Downtown Code Design Review Committee

Meeting Minutes

1) LC SoBro Phase II

2019DTC-026-001

Proposed North-South Cross Section

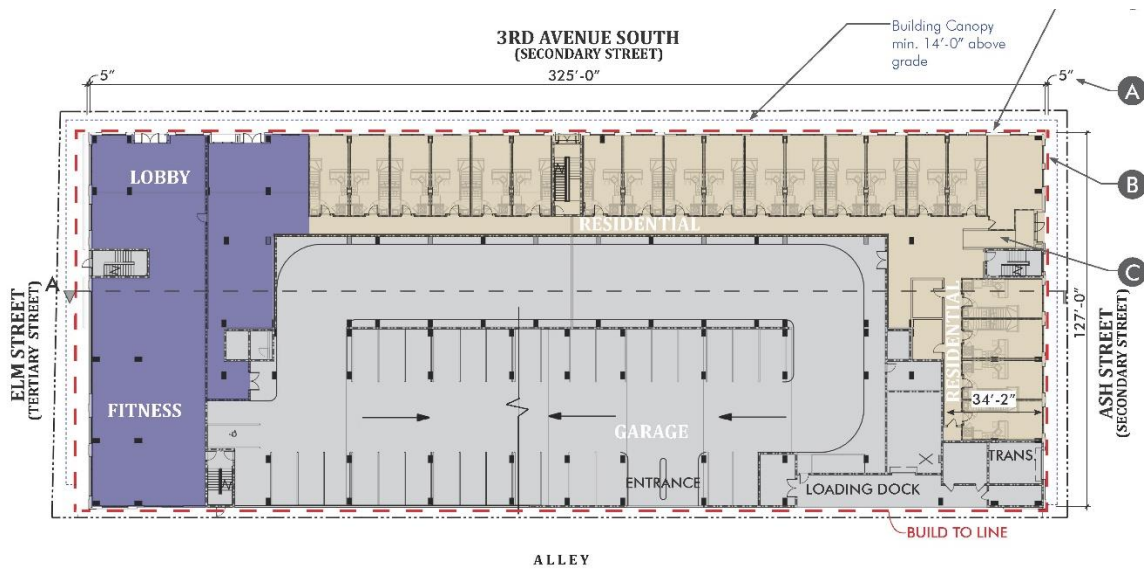
- Proposed: Along 3rd Ave South the building steps back at the 5th floor 65 feet at the amenity decks and 8 feet for the central residential portion. Along Elm Street the building steps back approximately 19 feet at the 7th floor at the corner of 3rd Ave South and Elm Street. Along Ash Street the building does not step back.

Proposed Ground Floor Plan

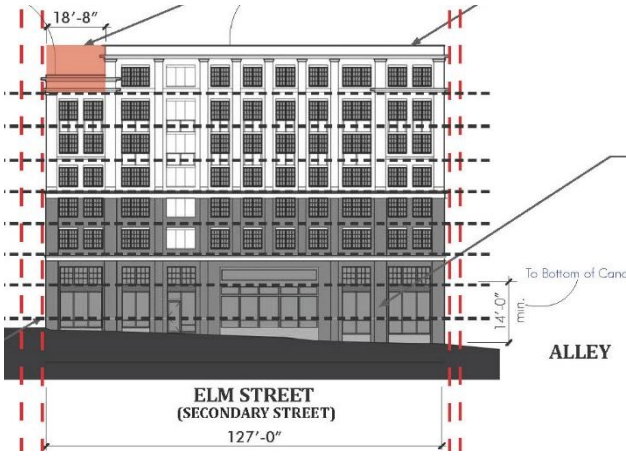
Along 3rd Avenue South the project proposes a 13-foot average ground floor height and along Ash Street the project proposes a 10-foot ground floor height. The requirement on both streets is a minimum 14-foot ground floor height. The DTC ground floor height requirement is for a storefront frontage, which is commonly used for commercial buildings; however, the proposed uses along 3rd Avenue South and Ash Street are residential. The project proposes 2 of the levels of the above grade parking to be fully lined with apartments and the floor heights correspond to the levels in the parking structure. The units on the ground floor are two story units that are only accessed from the ground floor. The façade is designed to appear as the required minimum 14-foot height from the outside.

Proposed North Elevation (Elm Street)

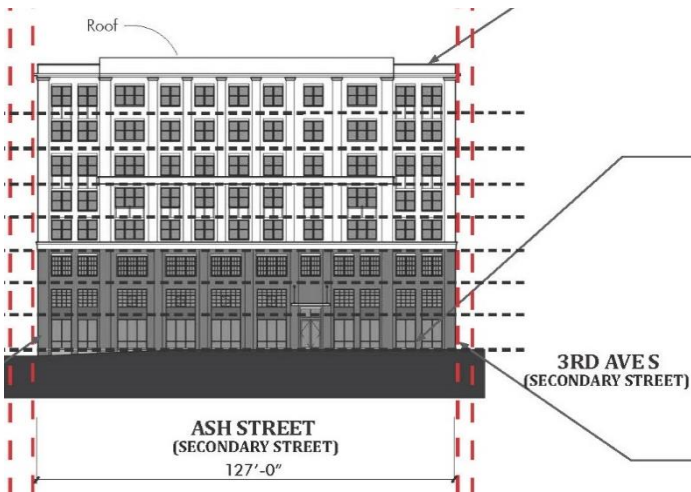
The building is proposed to step back along Elm Street approximately 19 feet at the 8th floor at the corner of Elm Street and 3rd Ave South and is not proposed to step back along Ash Street. These façades are the shorter ends of the building and approximately 127 feet in width. The mass of the building does not feel overwhelming to these streets due to the building proportions and the fact that the façades include a horizontal material change and banding. This architectural articulation improves the overall scale of the façades.

Step-back – 3rd Ave South, Elm Street, and Ash Street

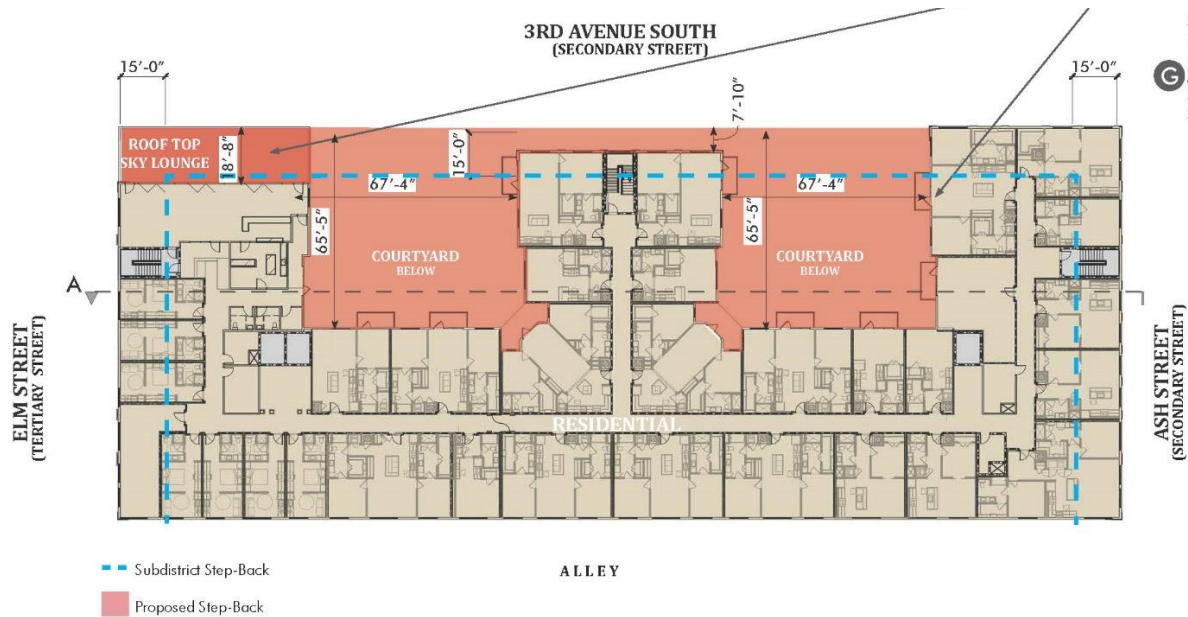
The DTC requires buildings 7 stories or greater to step back between the 4th and 7th stories. Along 3rd Ave South the façade width is approximately 325 feet; the building façade is broken up with two amenity decks on the fifth floor set back approximately 65 feet from the façade, and with residential units (on levels five-eight) arranged in an m-shape around the amenity decks. The modification along 3rd Ave South is for the units at the corner of 3rd Ave South and Ash Street that do not step back, the units at the corner of 3rd Ave South and Elm Street that step back on the eighth floor, and the units in the mid-point of the m-shape that step back 7'-10". This request is minor in nature. The amenity decks provide relief in the middle of the building and the block and break up the mass of the building so that there is not a long uninterrupted building wall fronting the street.

The proposed step-back modifications meet the intent of the DTC to maintain a low to mid-rise building wall along the street that does not overwhelm the street.
